Submissions and Amendment Report

SSD 9835 – Sydney Football Stadium Stage 2

Modification 7 – Precinct Village and Car Park

Submitted to NSW Department of Planning,
Industry and Environment

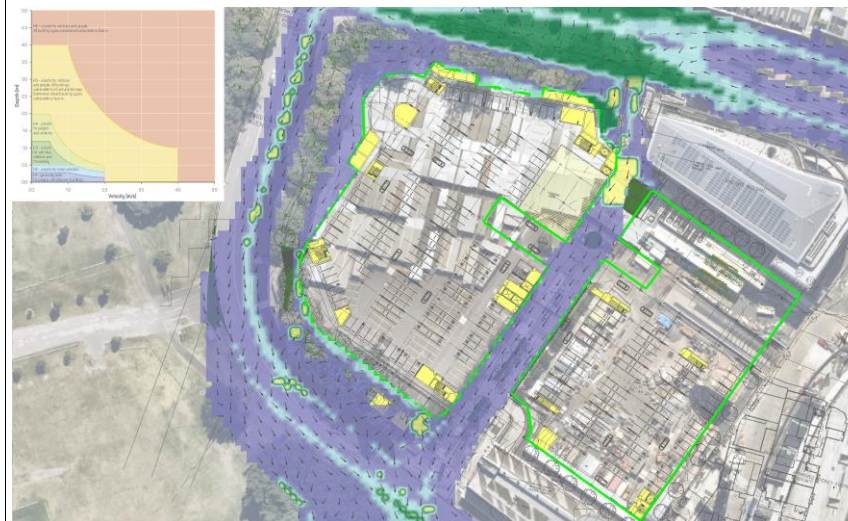
<p><i>Flood Risk to the Development</i></p> <p>EES raises concerns around the introduction of highly hazardous conditions on the proposed new road. EES advises against the creation of a new road with an H5 hazard category in the 1% annual exceedance probability (AEP) flood in an area of minimal flood hazard under existing conditions. EES notes that in a probable maximum flood (PMF), the hazard would be greater, and that PMF hazard categorisation should be mapped.</p> <p>It would not be unreasonable to contain hazardous flows to the proposed central flow path within the road. However, the modelling results do not demonstrate that this is achievable. In</p>	<p>Arup confirms that the design developments described above address the concerns raised by EES. The 1% AEP modelling hazard condition has been assessed to be H1 for much of the driveway between Stages 1 and 2. The proposed turning head on the central road is within the H1 zone.</p> <p>The areas of H5 have been moved further into the site, and the H3/H4 extents have been reduced, ensuring there is no worsening of hazards.</p> <p>Furthermore, the project will be subject to an Emergency Flood Evacuation Management Plan to be prepared, submitted, and approved by the Certifying Authority prior to occupation in accordance with Condition D30 of the consent. This plan will include</p>

the proposed design, flows are concentrated at the northern boundary, worsening flood hazard.

Further design work is recommended to ensure the safety of future road users. Otherwise, the proposal may result in a significantly increased requirement for government spending on emergency management services, flood mitigation and emergency response measures. A similar issue is present along the Moore Park Road frontage, where very high flood depths (deeper than one metre) are predicted under proposed conditions.

In relation to the carpark entries, as noted in Section 8.3 of the Precinct Village and Car Park (MOD 7) Stormwater and Flooding Assessment (September, 2021), the concept design provided permanent protection from 1% AEP overland flows grading of the central road. Flood gates were only included to provide protection beyond the 1% AEP up to the greater of the 1% AEP plus 500mm freeboard or PMF level, as required by the *City of Sydney Interim Floodplain Management Policy* for entries connecting to basements. As noted in the response to the previous comment, as part of ongoing design development the central driveway has since been lowered to remove the requirement for flood gates.

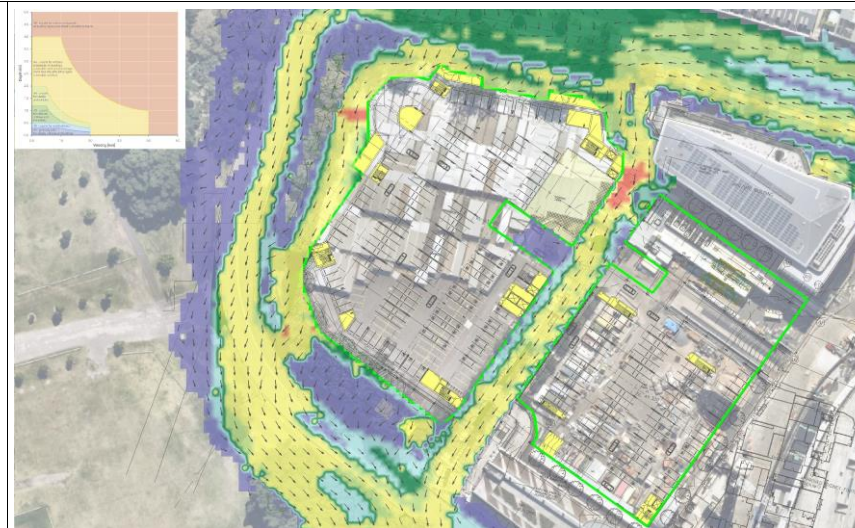
Clarification is requested around the flood impact maps. Figure 8 is titled 1% AEP flood depth afflux map, while in Appendix A, Figure 004 is titled Peak Flood Level Change. The two figures appear to show the same information, and flood level impacts are the more robust measure of change. The consultant could justify using depth impacts if necessary and assuming depth impacts have not been used to mask true impacts.

EES raises concerns around flood impacts to Driver Avenue. The Precinct Village and Car Park (MOD 7) Stormwater and Flooding Assessment, dated 6 September 2021, states flood levels would increase up to 50mm. However, the predicted impacts, as per Figure 8 of the Stormwater and Flooding Assessment shows up to a 0.3m increase in flood levels. This should be clarified.

Regardless, a 50mm increase is a significant adverse impact, well beyond the commonly accepted limit of 10mm. Notably, the highest increase occurs where the existing flood risk is greatest, exacerbating these conditions. EES recommends the applicant introduce mitigation measures to avoid worsening existing flooding conditions. Alternatively, the change in hazard category (H1-H6) could be mapped to assess if there is a significant change in hazard.

To provide clarification around the flood impact maps provided in the report, Arup confirm that both Figure 8 and Appendix A, Figure 004 display flood level afflux – the title of Figure 8 is incorrect and should read “Figure 8: 1% AEP flood level afflux map”.

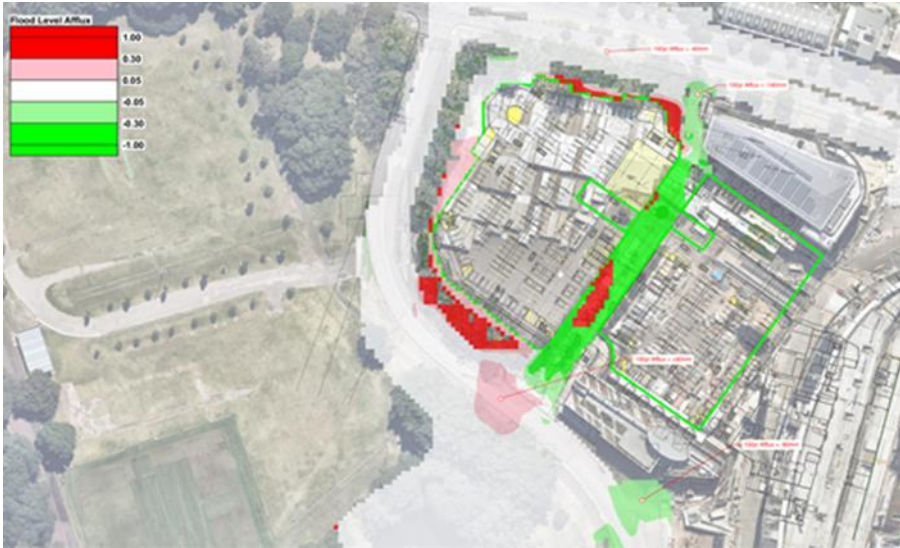
Overland flow and localised flooding in 1 in 100 year storms are an issue on the northern edge of western car park basement. Storm water is to be channelled around the site.

Architect section L (dwg A42.00.20 [B]) shows a stormwater culvert at the edge of the carpark located over the top of carpark plenums. It is queried whether stormwater and air intake can be mingled and clarification on this is requested.

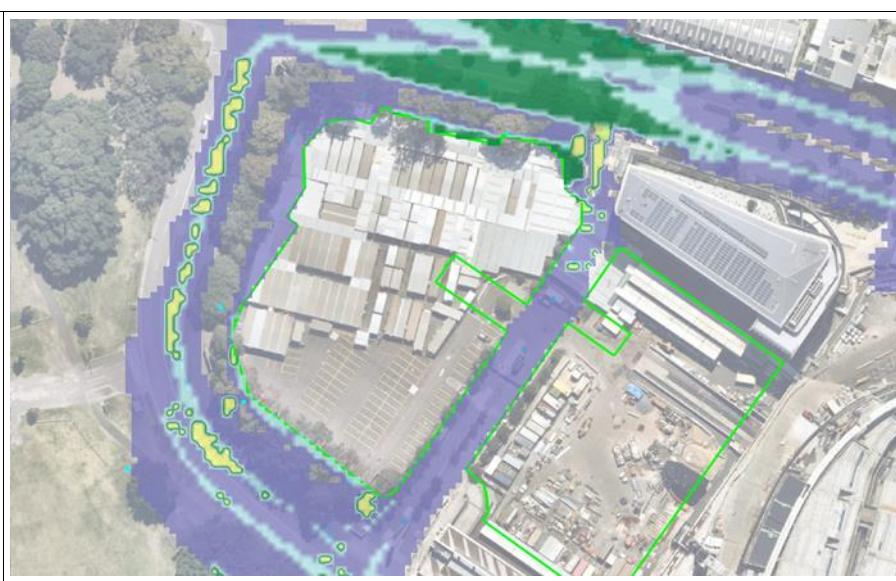
The afflux for the 100 year event shows the changes to the overland flow on the western side of the stage 2 development are localised, further development of the design with respect to the mechanical risers and the stormwater diversion is underway.

The hazard in the 100 year solution for the western side remains H1 which is acceptable.
